Groundwater Transfer Review Summary Form

Transfer/PA # T- 14344

Ground Water Review Form:

Applicant Name: Weyerhaeuser NR Co.

Hunt 1999-POA 1/Pump Well 1/MARI 16005

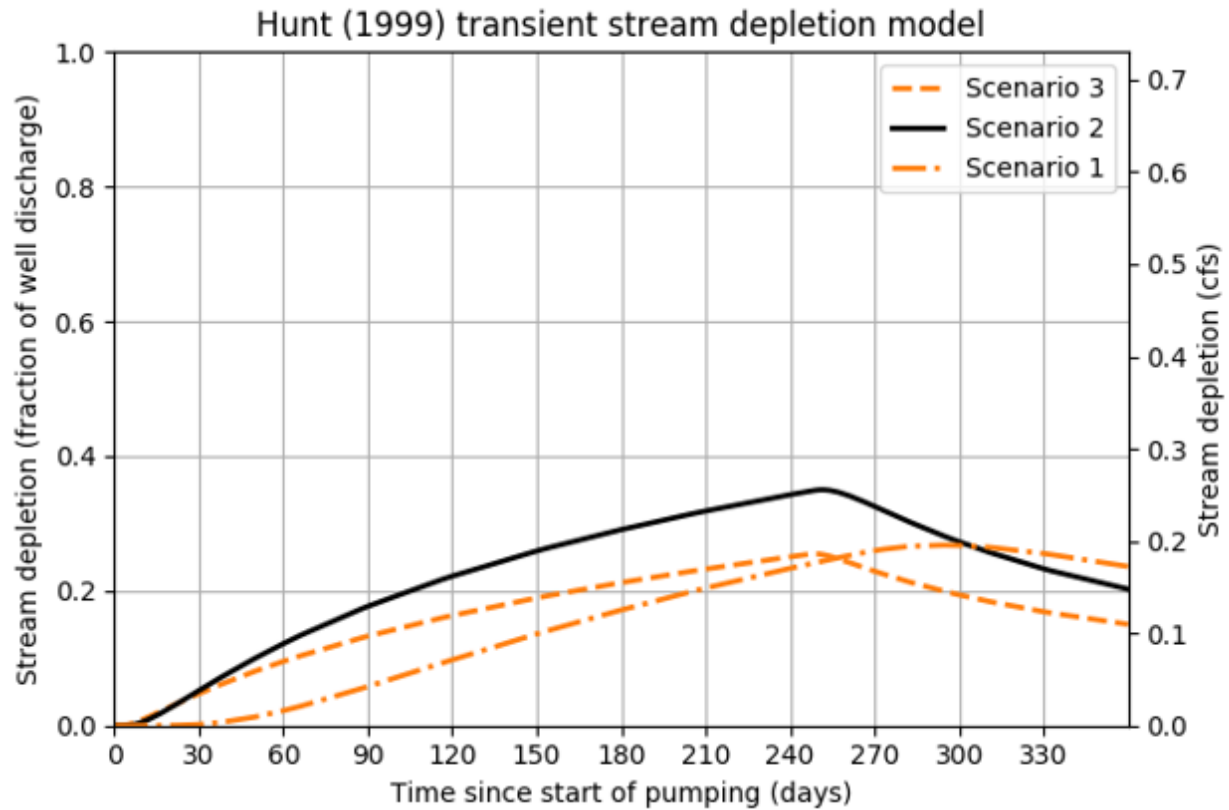
Application type:	T
Application number:	14344
Well number:	1
Stream Number:	1
Pumping rate (cfs):	0.73
Pumping duration (days):	245.0
Pumping start month number (3=March)	3.0

Stream depletion for Scenario 2:													
Days	10	330	360	30	60	90	120	150	180	210	240	270	300
Depletion (%)	1	23	20	5	12	18	22	26	29	32	34	33	27
Depletion (cfs)	0.00	0.17	0.15	0.04	0.09	0.13	0.16	0.19	0.21	0.23	0.25	0.24	0.20

Hunt 1999 POA 3/New Greenhouse Well/PROP 482 (at full non-reduced rate)

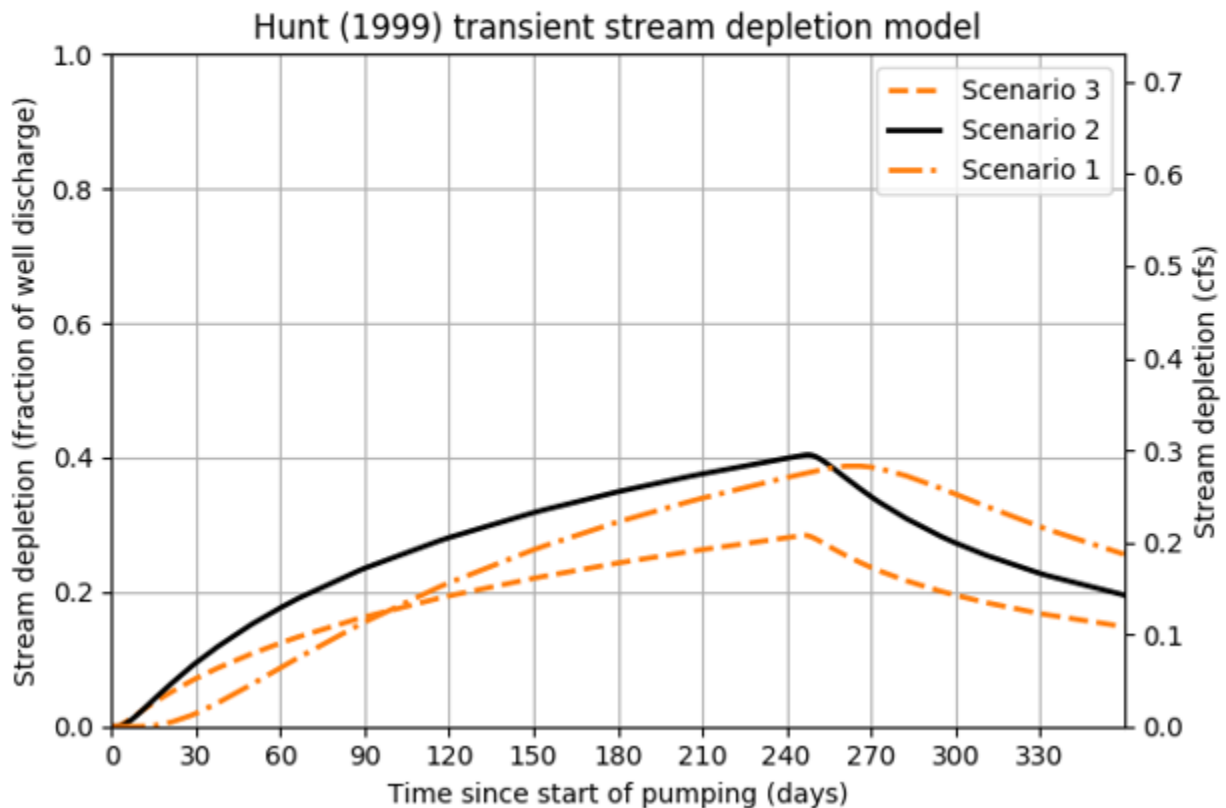
Application type:	T
Application number:	14344
Well number:	3
Stream Number:	1
Pumping rate (cfs):	0.73
Pumping duration (days):	245.0
Pumping start month number (3=March)	3.0

Days	10	330	360	30	60	90	120	150	180	210	240	270	300
Depletion (%)	2	23	20	9	18	24	28	32	35	38	40	34	27
Depletion (cfs)	0.01	0.17	0.14	0.07	0.13	0.17	0.21	0.23	0.25	0.27	0.29	0.25	0.20

8. Any additional comments: To avoid a Significant Change in Degree of Interference with the North Santiam River, the pumping rate can be reduced for POA 3/New Greenhouse Well (PROP 482) and POA 4/Well 4 (PROP 483) such that the degree of interference for the months the North Santiam is over-appropriated (August, September, October) is the same as produced by pumping at the maximum rate at the authorized POA closest to the North Santiam River, POA 1/Pump Well 1/MARI 16005). The reduced rate to achieve the same degree of interference as POA 1/Pump Well 1/MARI 16005 is 0.607 cfs (272.6 gpm) for POA 3/New Greenhouse Well (PROP 482), and 0.592 cfs (265.8 gpm) for POA 4/Well 4 (PROP 483).
